HISTORIC AND DESIGN REVIEW COMMISSION

August 18, 2021

HDRC CASE NO: 2021-382
ADDRESS: 535 MISSION ST
LEGAL DESCRIPTION: NCB 2879 BLK 4 LOT 17
ZONING: RM-4, H
CITY COUNCIL DIST.: 1
DISTRICT: King William Historic District
APPLICANT: Lisa Garza
OWNER: HERRERA DAWN Q
TYPE OF WORK: Front porch modifications
APPLICATION RECEIVED: August 02, 2021
60-DAY REVIEW: Not applicable due to City Council Emergency Orders
CASE MANAGER: Rachel Rettaliata

1. Install a raised front porch with metal railings and decorative skirting.
2. Modify the existing front walkway.

SITE PLAN

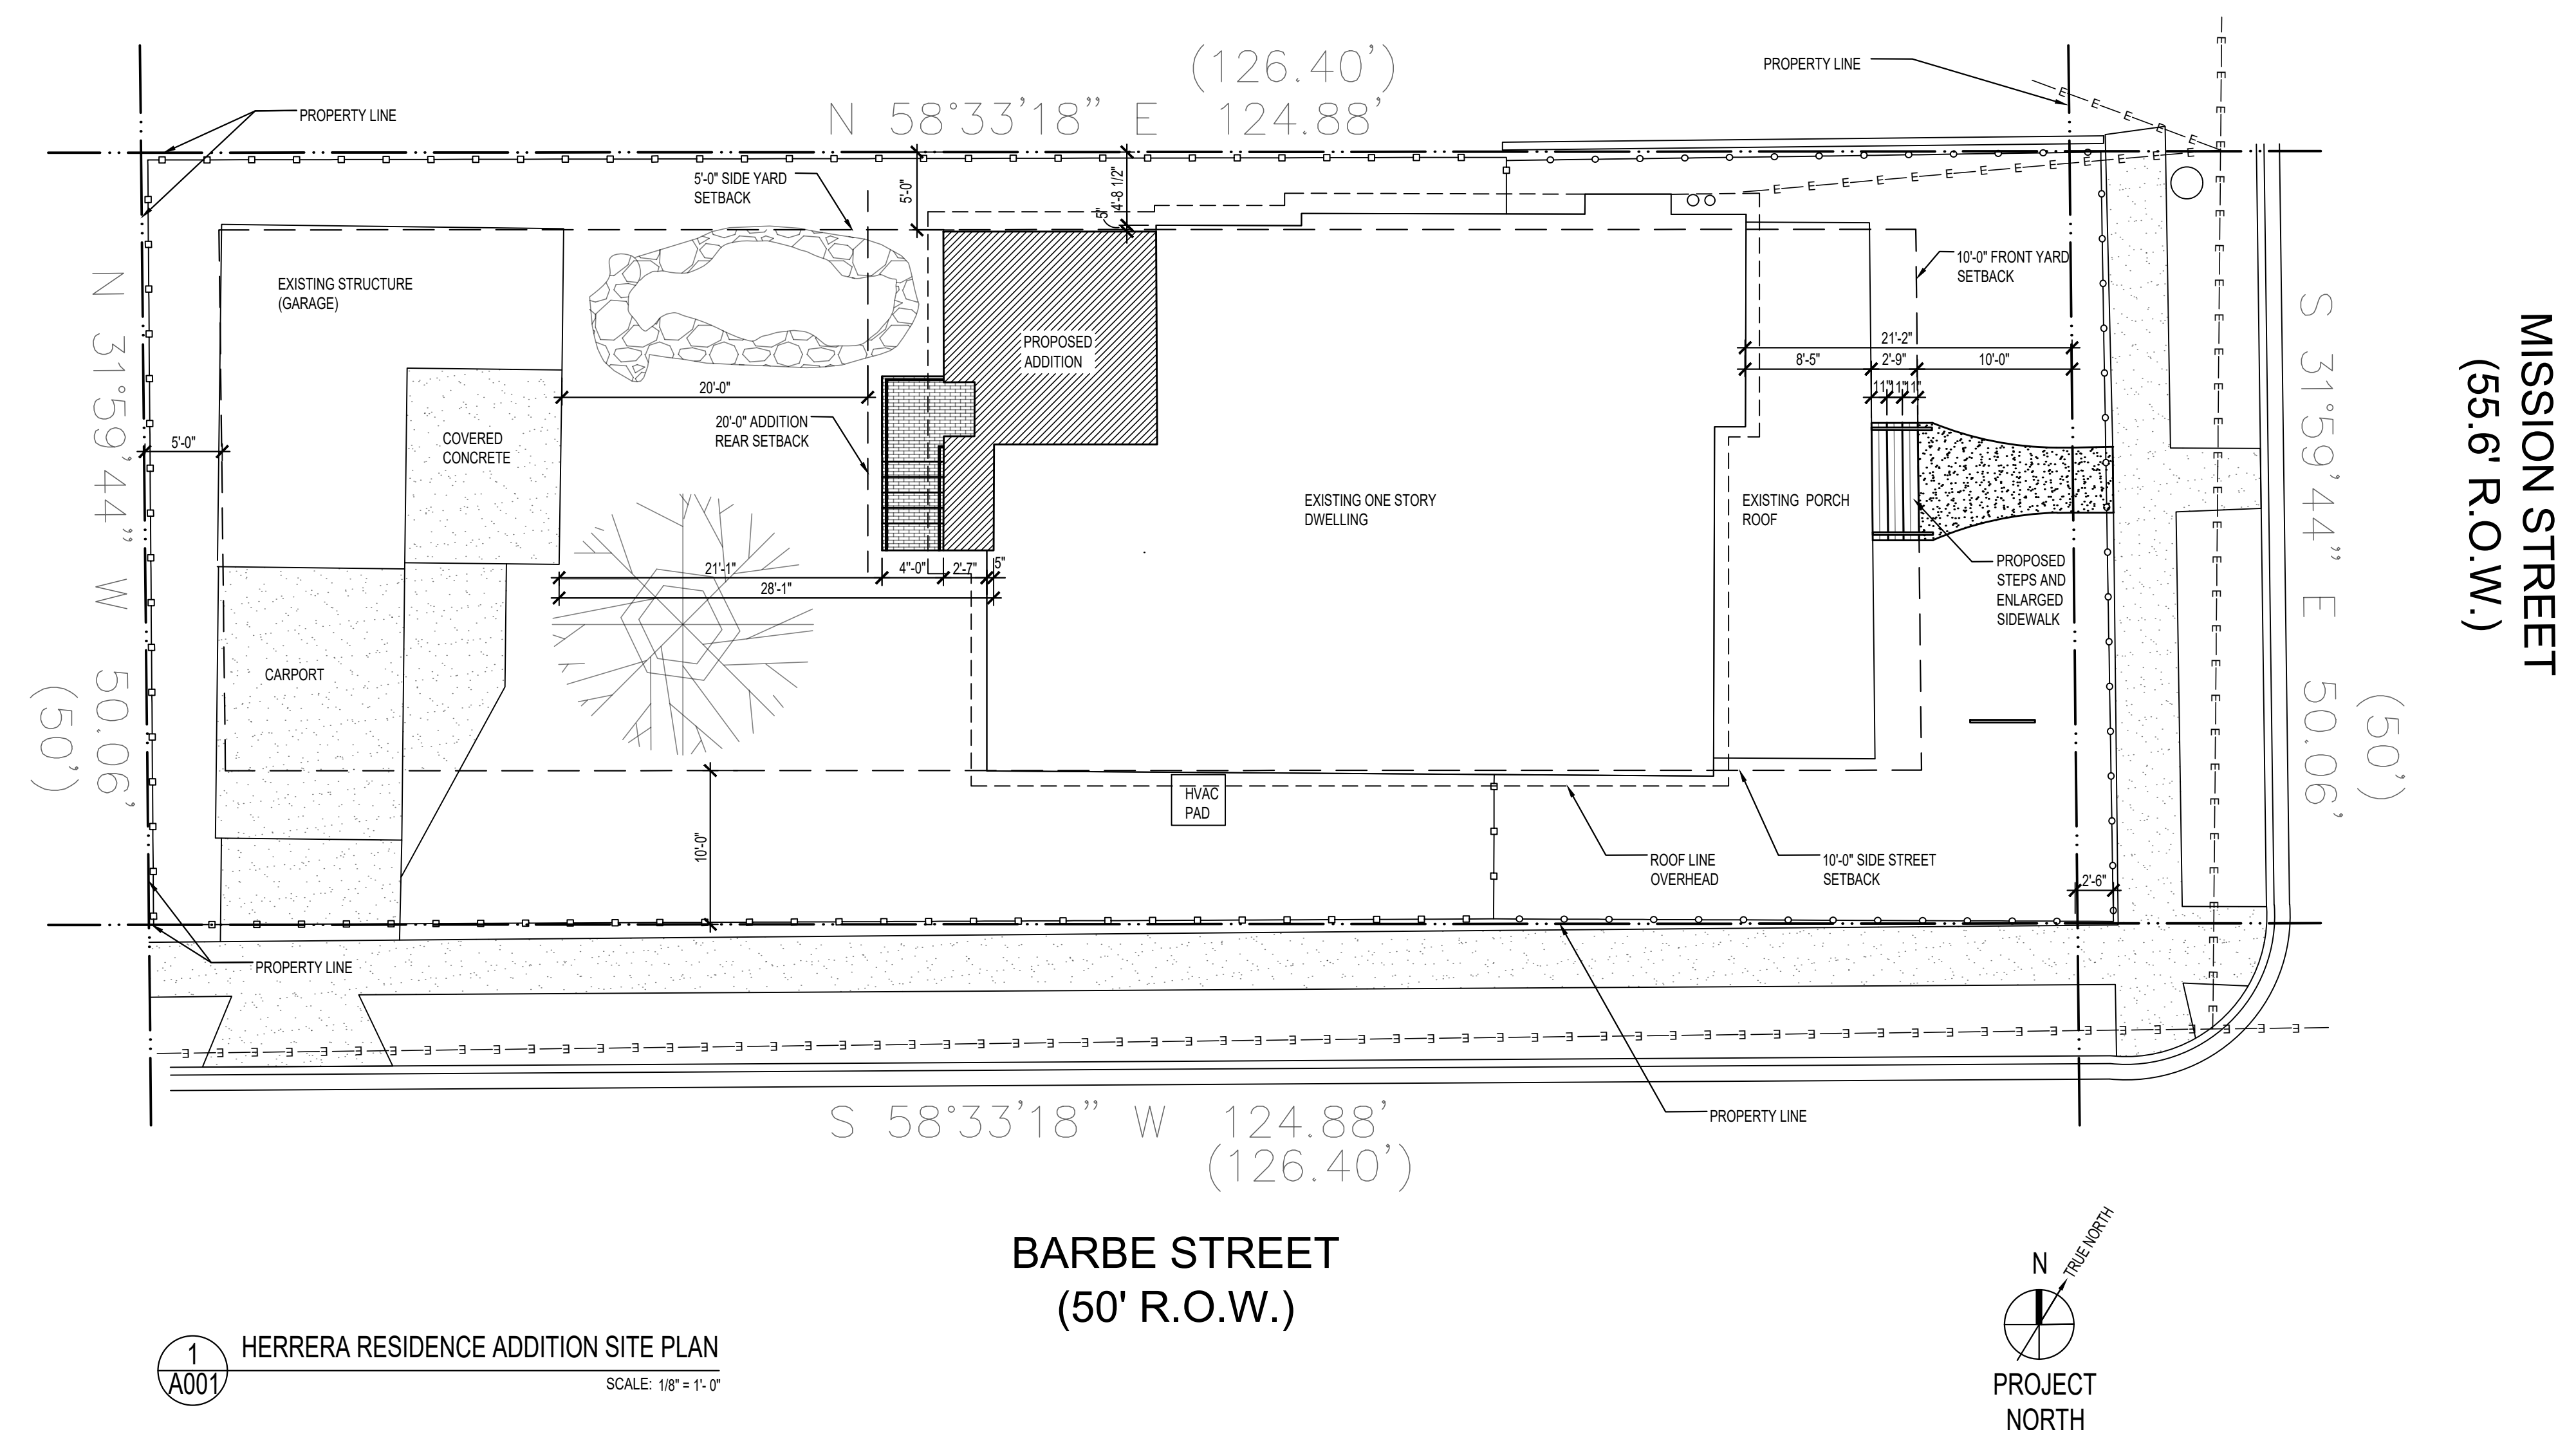
- f. FRONT WALKWAY MODIFICATION – The applicant has proposed to modify the existing front walkway to feature a wide mouth at the front porch steps, flaring from 4'-4" to 7'-6". Guideline 5.A.iii for Site Elements states that the historic alignment, configuration, and width of sidewalks and walkways should be followed. Alter the historic width or alignment only where absolutely necessary to accommodate the preservation of a significant tree. Staff finds the proposal inconsistent with the Guidelines.

Item 2, staff does not recommend approval of the front walkway modification based on finding f. Staff recommends that the applicant maintains the footprint of the existing walkway.

ELEVATIONS

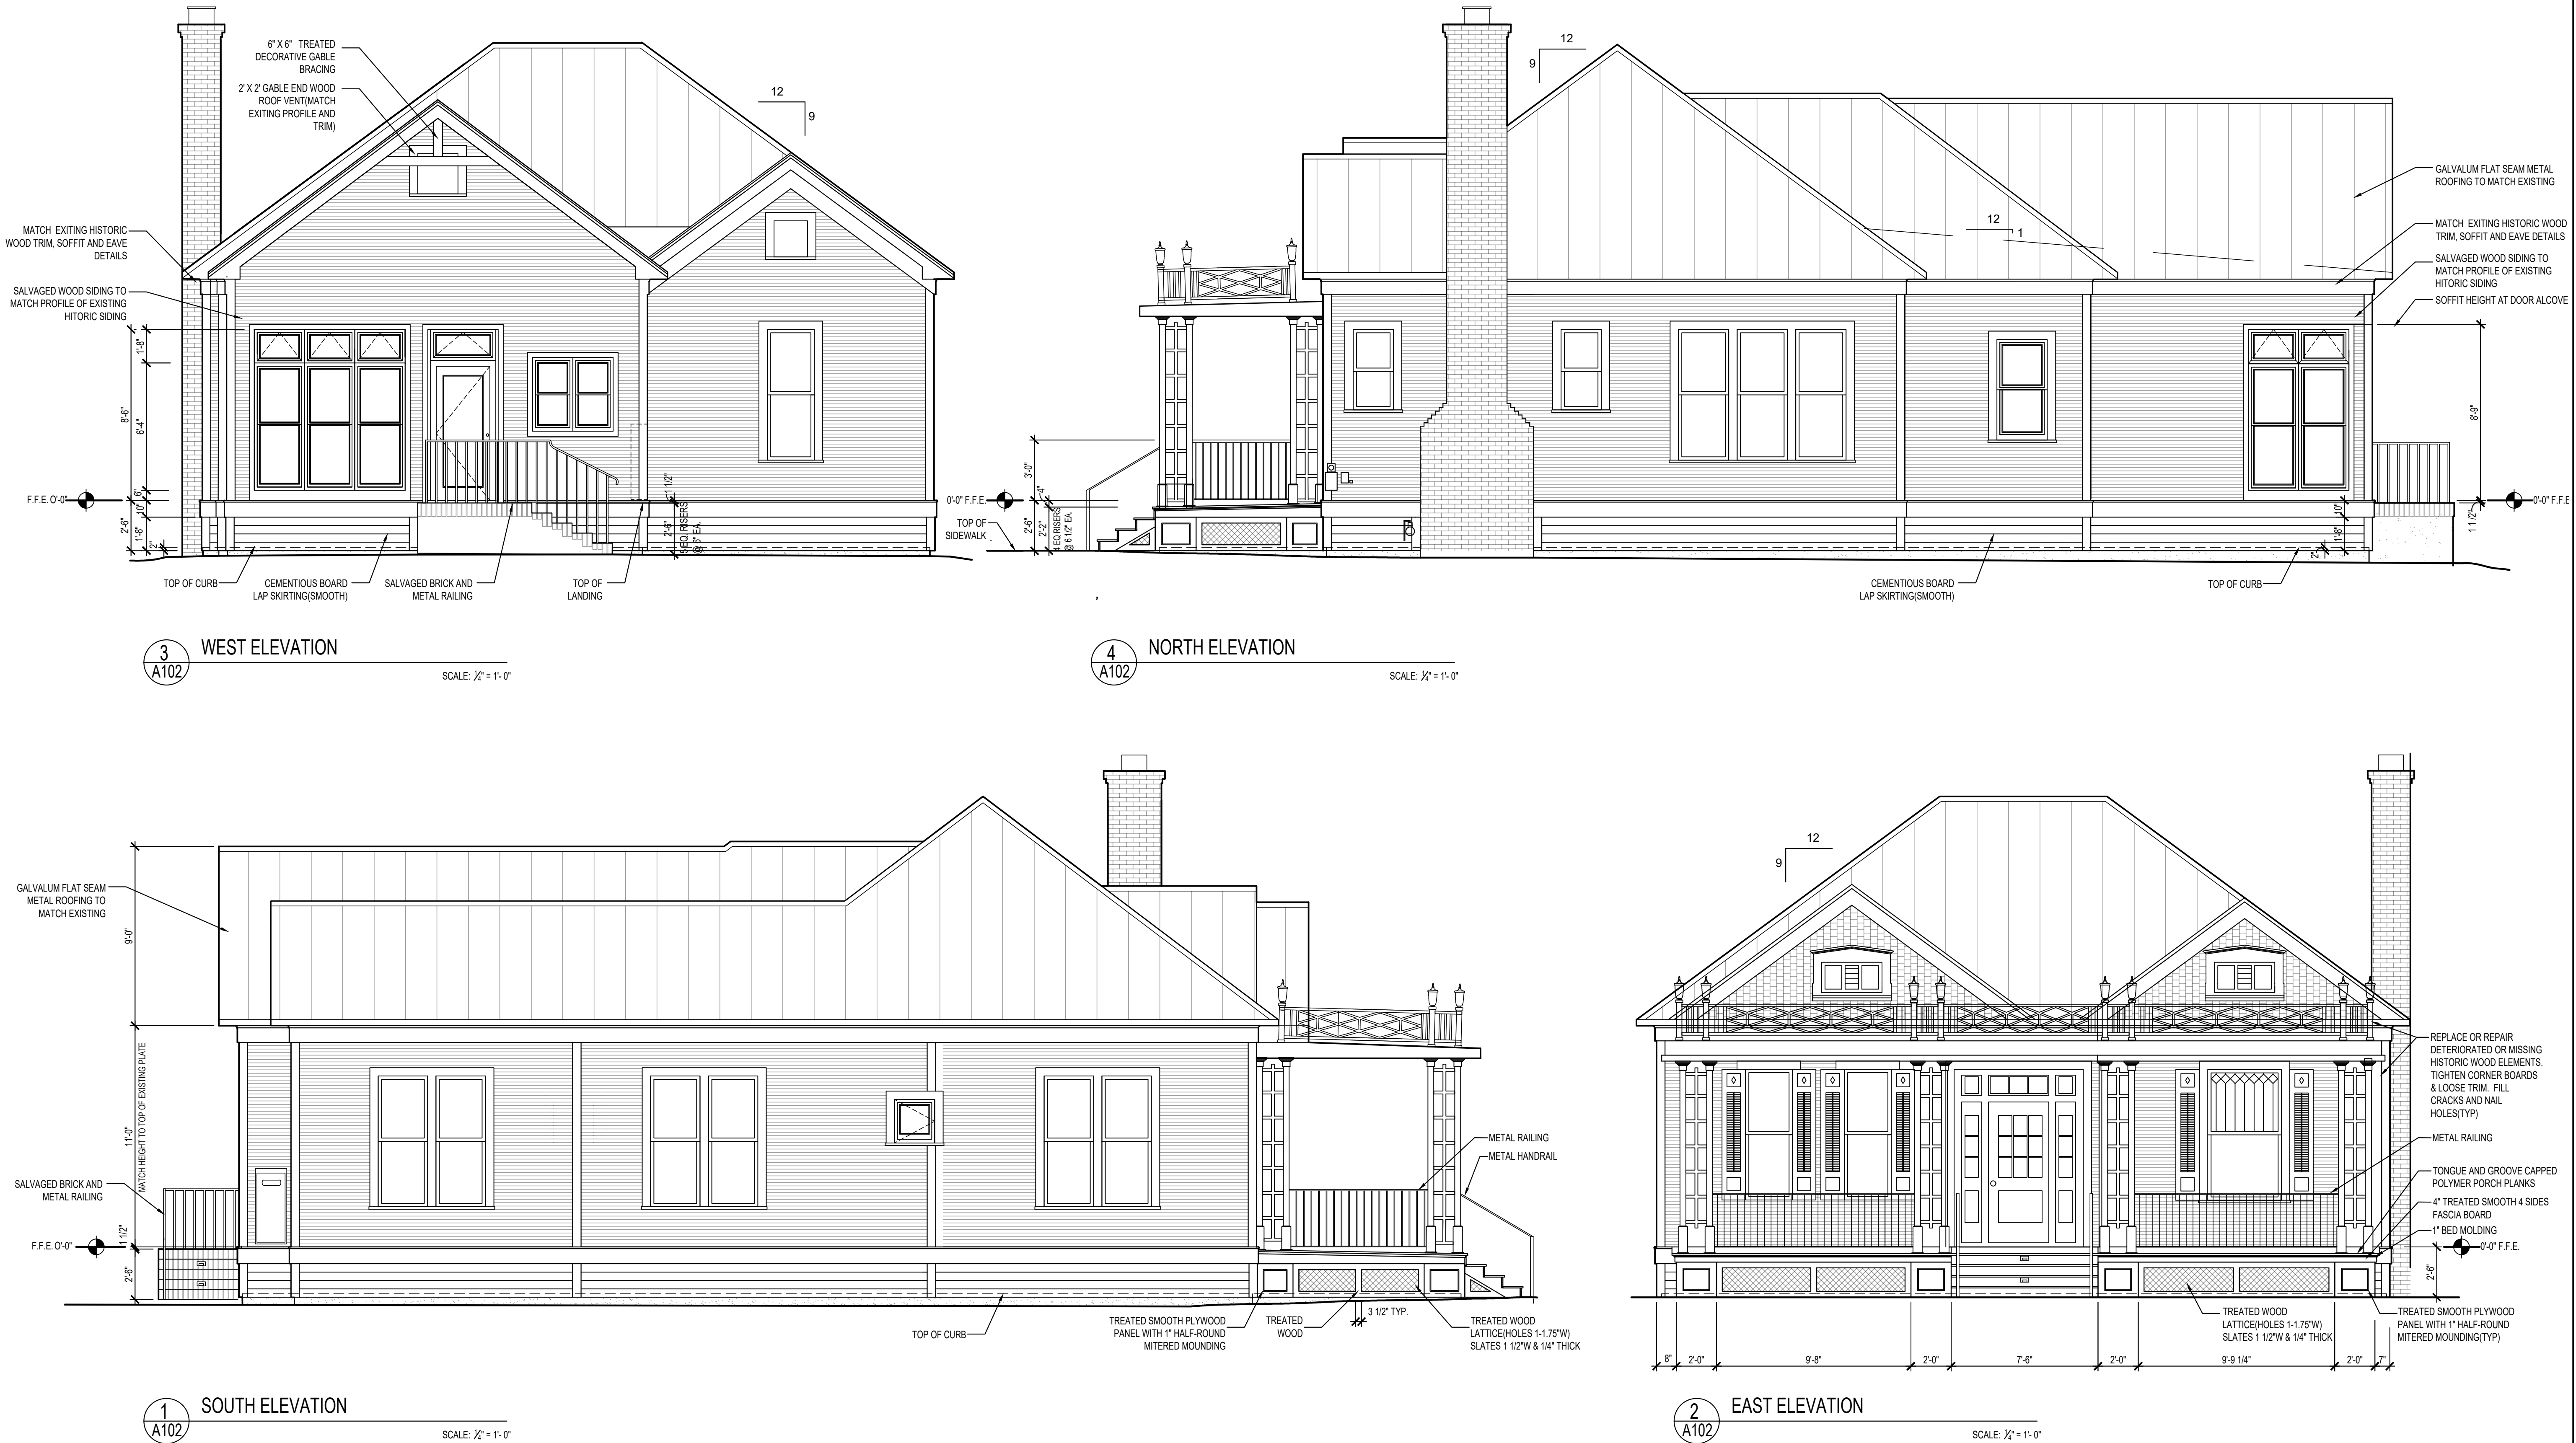
- b. **RAISED FRONT PORCH INSTALLATION** – The applicant has proposed to install a new raised front porch to be installed at 2'-6" above grade to meet the front door. The existing front porch roof and columns will not be modified. The existing front porch decking consists of a concrete slab on grade on level with the front yard. A set of stairs and a stoop with a metal railing are currently located at the front door. The 1912 and 1951 Sanborn Maps show that the structure originally featured an asymmetrical front porch, and the location of the front door would suggest that the original front porch was raised. Guideline 7.A.i for Exterior Maintenance and Alterations states that porches should be preserved. Do not add new porches, balconies, or porte-cocheres where not historically present. Additionally, Guideline 7.B.v states that porches should be reconstructed based on accurate evidence of the original, such as photographs. If no such evidence exists, the design should be based on the architectural style of the building and historic patterns. As the existing structure has been modified over time and the double front gables were likely a later addition, staff finds that the installation of a raised full width front porch to correspond to the existing full width front porch to be appropriate.

- c. **RAISED FRONT PORCH: MATERIALS** – The applicant has proposed to install 3 ½" wide tongue and groove capped polymer porch decking on the raised front porch. Guideline 7.B.v for Exterior Maintenance and Alterations states that when reconstructing porches, the design should be based on the architectural style of the building and historic patterns. The applicant has not provided material specifications for the front porch steps at this time. Staff finds that wood decking and wood steps would be most appropriate. New porch decking should feature 1" x 3" tongue-and-groove wood members laid perpendicular to the front façade plane.

- d. **METAL RAILING INSTALLATION** – The applicant has proposed to install metal railings on the proposed raised front porch to match the existing metal railing on the front door stoop. Guideline 7.A.ii for Exterior

Maintenance and Alterations, when the replacement of balusters is necessary, replace in-kind when possible or with balusters that match the originals in terms of materials, spacing, profile, dimension, finish, and height of the railing. While the original baluster is not extant, staff finds that a wood baluster or wood railing would be most appropriate. The new railing should feature both a top and bottom rail. The bottom rail should feature a vertical orientation and should be installed approximately three to four inches above the porch decking. Both top and bottom rails should be constructed from 2"x4" members. The proposed railing should not feature an overall height of more than three (3) feet.

- e. DECORATIVE SKIRTING INSTALLATION – The applicant has proposed to install treated wood lattice and treated smooth plywood panels with 1-inch half-round mitered mounding at the base of the proposed raised front porch as the skirting. According to Guideline 7.B.iv for Exterior Maintenance and Alterations, replacement elements should be designed to be simple so as to not distract from the historic character of the building. Do not add new elements and details that create a false historic appearance. Staff finds that due to the decorative and eclectic character of the primary structure, the proposed skirting is appropriate.

Item 1, staff recommends approval of the raised front porch installation based on findings a through e with the following stipulations:

- i. That the applicant submits final material specifications for fully wood front porch steps to staff for review and approval prior to the issuance of a Certificate of Appropriateness.
- ii. That the applicant installs fully wood front porch decking. The decking must feature 1" x 3" tongue-and-groove wood members laid perpendicular to the front façade plane.
- iii. That the applicant installs a fully wood front porch railing. The wood railing must feature both a top and bottom rail. The bottom rail should feature a vertical orientation and should be installed approximately three to four inches above the porch decking. Both top and bottom rails should be constructed from 2"x4" members. The proposed railing should not feature an overall height of more than three (3) feet.
